SUBJECT: NORTH ANNA POWER STATION, UNITS 1 AND 2 RE: INSERVICE TESTING
PROGRAM FOR PUMP AND VALVES, THIRD TEN YEAR INTERVAL UPDATE
(TAC NOS. MB2221 AND MB2222)

SAFETY EVALUATION BY THE OFFICE OF NUCLEAR REACTOR REGULATION
RELATED TO THE THIRD 10-YEAR INTERVAL INSERVICE TESTING PROGRAM

NORTH ANNA POWER STATION, UNITS 1 AND 2

Figure No. P-6.1

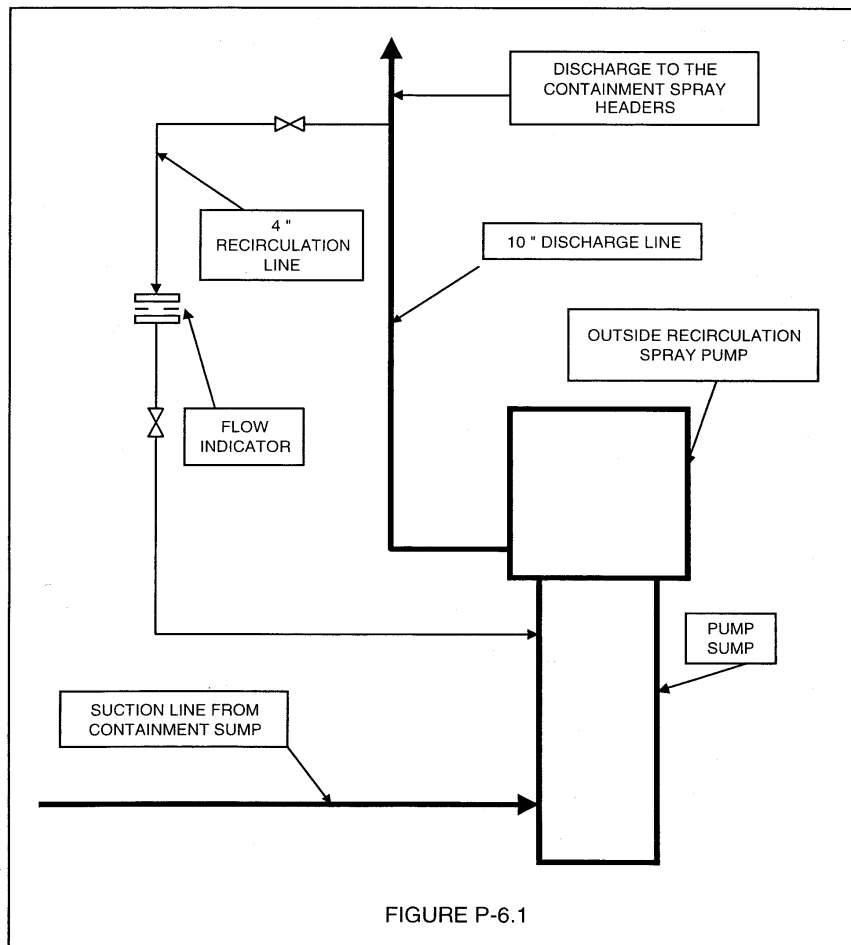
The test loop for the outside recirculation pumps consists of a 10" pump discharge line feeding into a 4" recirculation line which feeds back to the pump sump. Refer to Figure P-6.1. With test loop, pump design flow cannot be established. Also, the discharge piping was not designed to be temporarily reconfigured so that pump design flow could be achieved.

As an alternative to flow testing at the design flow rate, the test loop shown in Figure P-6.1 will be used. Reference flows are typically established with test loop in the range of 1450 to 1500 gpm, whereas the pump design flow is 3640 gpm. The low reference flows result from restrictions due to the small 4" recirculation line and the limited volume of water in the test loop. The limited water volume results in a rapid temperature rise in the test loop due to heat loads added by the running pump. This temperature rise affects repeatability of the measured hydraulic parameters. Therefore, care must be taken to ensure that the pump run time is limited and that the flow rate is maintained within an optimal range.

As an alternative to the flow testing at design flow rate, the licensee has proposed testing with a test loop shown in Figure P-6.1. The test loop is a 4-inch recirculation line. The reference flows established with this test loop are in the range of 1450 to 1500 gpm whereas the pump design flow is 3640 gpm. The low reference flows are limited due to size of 4-inch recirculation line. The limited water volume and the heat loads added by the running pump will rapidly raise the temperature of the water in the test loop. The testing will be performed in a manner to ensure that the pump run time is limited and the flow is maintained within an optimal range. The highest flow that can be measured while maintaining stable test conditions is approximately 40 percent of design flow. Measuring more than one point on the pump curve is limited to flow rates less than the 1450 to 1500 gpm range. Throttling the flow down to 20 percent of design flow to measure another point on the curve may cause flashing across the throttle valve producing hydraulic instabilities and less-than-meaningful results. In the 1450 to 1500 gpm range of the head curve for these pumps, the head curve is not flat but well sloped. (See Figure P-6.2 for Units 1 and 2). As shown in the Figure P-6.2, the test point falls on the nominal vendor curve. Any deviation from the nominal curve will show degradation of the pump.

FIGURE P-6.2 (UNIT-1)

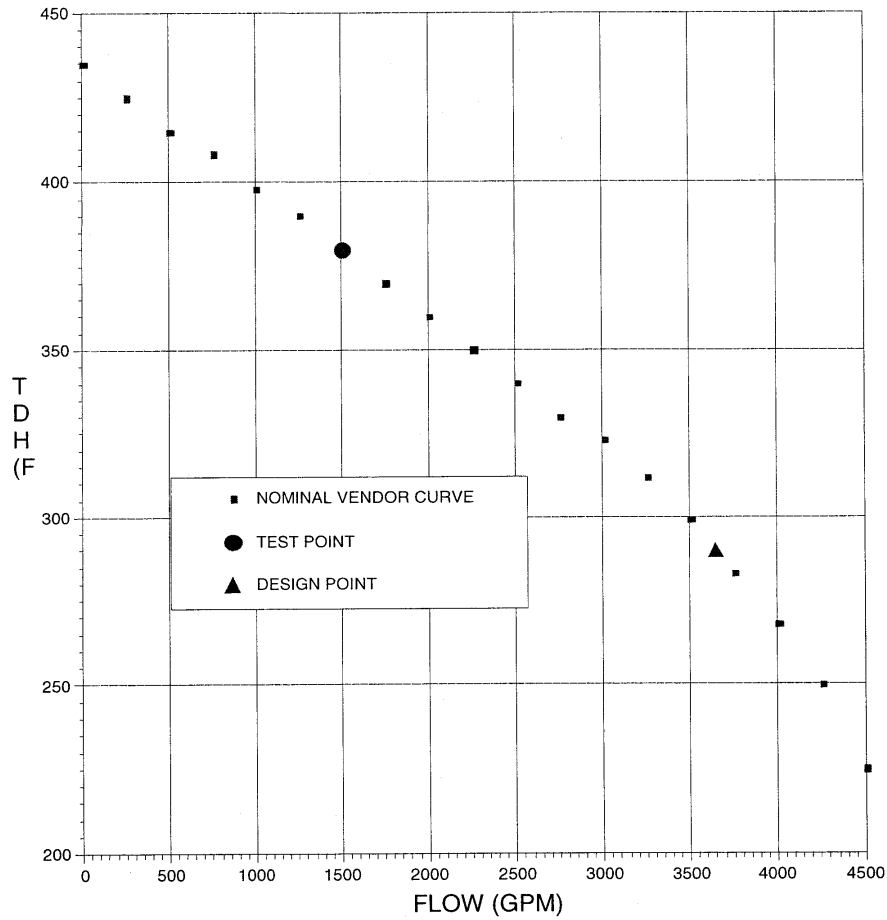
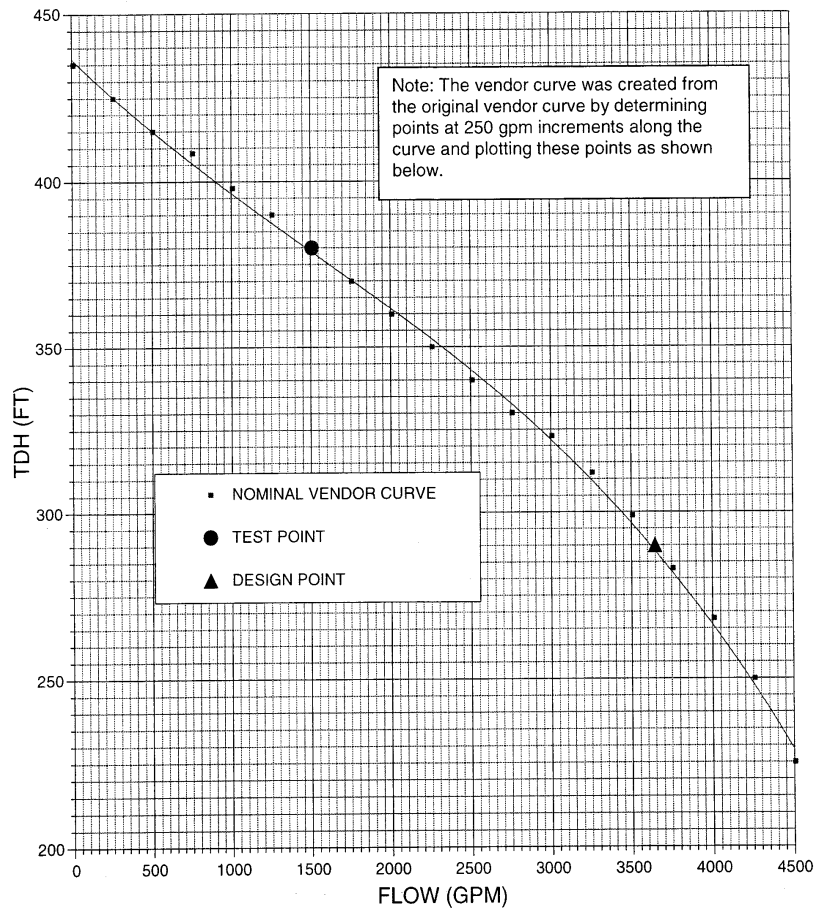
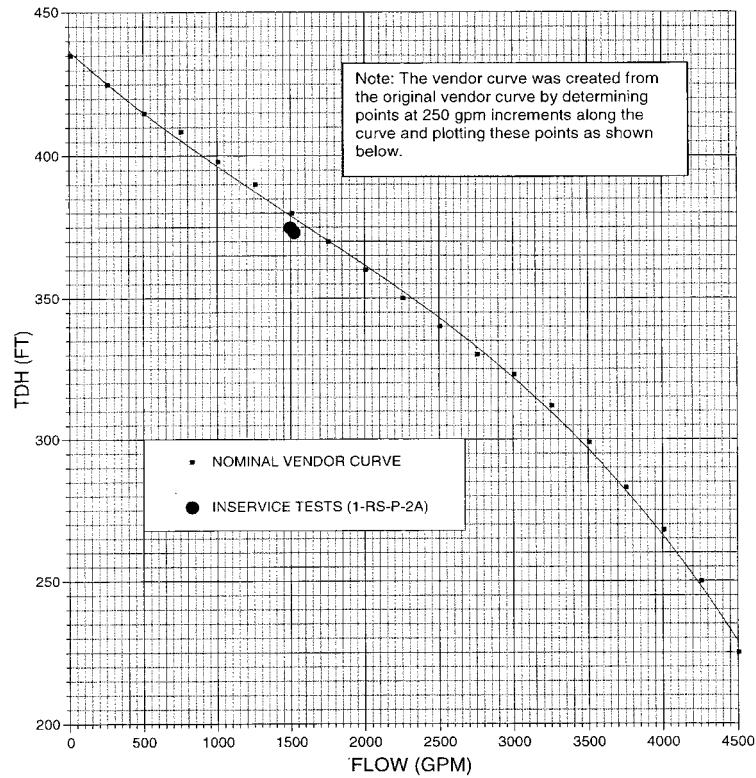
In the 1450 to 1500 gpm range of the head curve for these pumps, the head curve is not flat, but well sloped. Refer to Figure P-6.2. Therefore, as performance degrades due to internal recirculation caused by increasing internal pump clearances, the differential pressure will measurably decrease for a given reference flow rate. As discussed above, testing the outside recirculation spray pumps over the full range of the pump curve and measuring at least five points along the curve is impractical.

As an alternative to testing within 20% of the design flow, the reference values will be established at approximately 40% of the design flow. It is our understanding that testing at design flow is important for pumps with characteristic head-flow curves that are flat or gently sloping in the low flow region (little change in developed head with increasing flow). In the low flow region, increasing internal flows, usually due to wear, are difficult if not possible to detect. Pumps with the "flat" curves at low flows should be tested at near design conditions to determine if increasing internal recirculation flows have degraded pump performance to the point where design requirements cannot be met. This situation does not apply to the outside recirculation pumps if they are tested at 40% of design flow. Testing at the reference flows will detect pump degradation because the pump curve is well sloped at the point of testing. Refer to Figure P-6.2. [for Units 1 and 2]

From Figure P-6.2, the nominal vendor curves, the shutoff head of pumps is 435 feet. As discussed above, the pump can only be tested on a recirculation flow path which is sized for approximately 40 percent (1500 gpm) of the design flow of 3640 gpm. In case of Seabrook Station, Unit 1 (Reference 5), the shutoff head is 700 ft. The pump can be tested on recirculation flow path which is sized for approximately 68 percent (1900 gpm) of the required design flow of 2808 gpm. The flow and TDH values from the head-flow curves for North Anna Station and Seabrook Station (Reference 5) are shown in the following table for comparisons:

The licensee provided curves (Figure P-6.2) showing flow rate versus the corresponding TDH. The intent of the curve is to provide trend data on the TDH at each measured flow rate for the outside recirculation pumps. The expected result is that at higher flow rates, there is a lower pump TDH. This provides an indication that the pumps were tested in an area of the curve where the intent of the comprehensive test would be satisfied.

Figure No. P-6.3

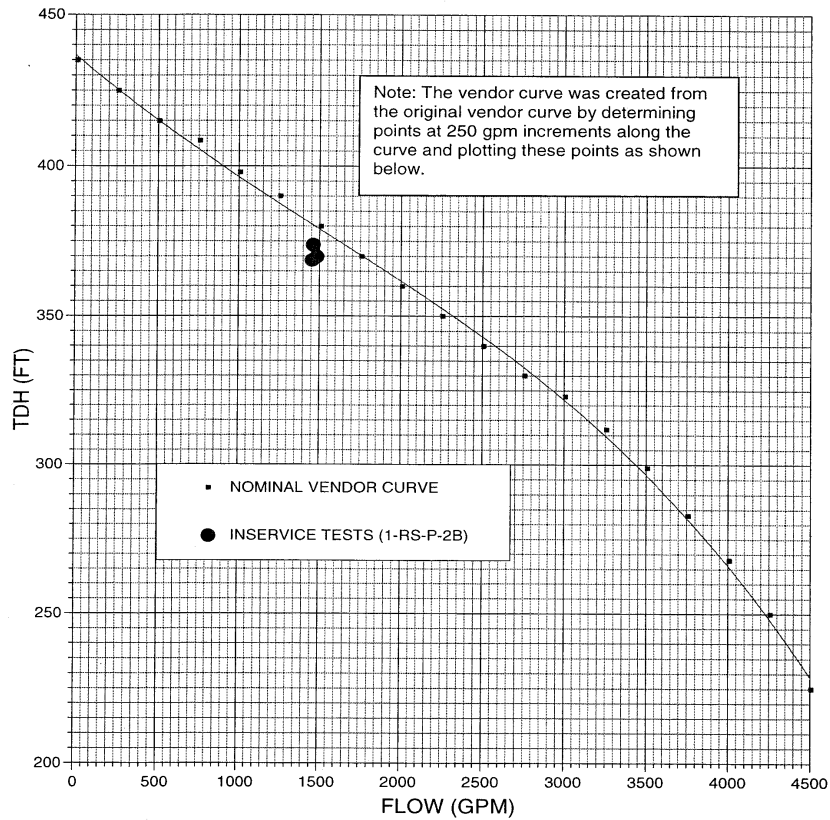
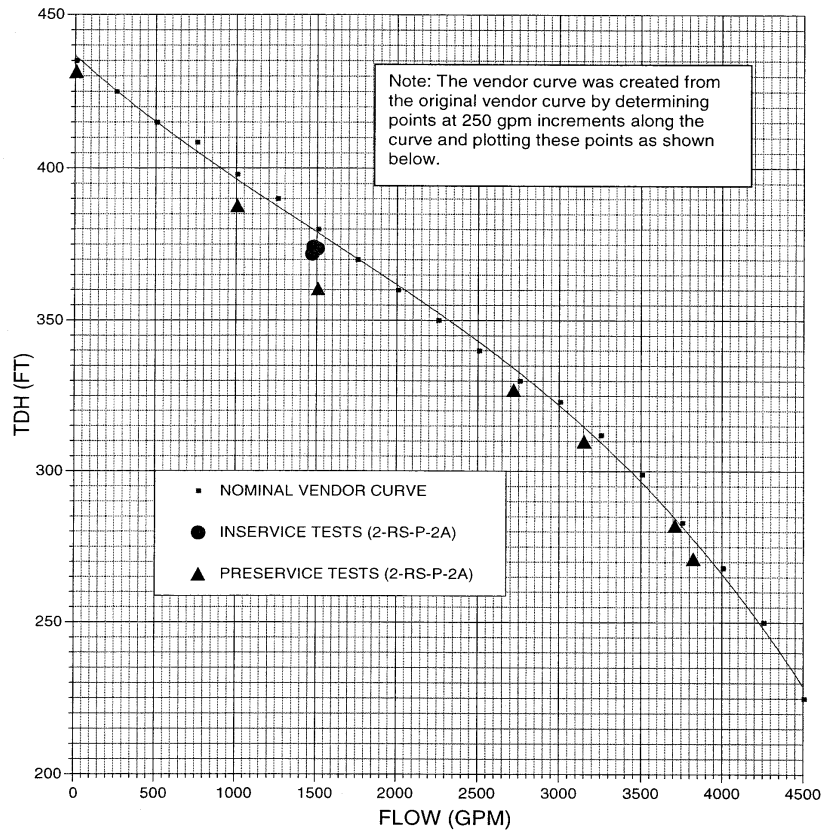
The licensee provided pump curves for Units 1 and 2. Figures P-6.3 and P-6.4 are for Unit 1 outside recirculating spray pumps 1-RS-P-2A and 2B. The curves in these figures show nominal vendor curves with inservice test points. For Unit 2 pumps 2-RS-P-2A and B, the curves in Figures P-6.5 and P-6.6 show not only inservice test points but preservice test points. The reason is that the licensee performed preservice tests for Unit 2 pumps only due to hardship as explained by the licensee in the Section 3.6.2 above. The Unit 2 pump curves shows that the slopes of the nominal vendor curves and the preservice test are very close. The slopes of the Unit 1 pump pretest curves would presumably have resembled the slopes of the Unit 2 pump preservice tests, because the Units 1 and 2 pumps are similar. Therefore,
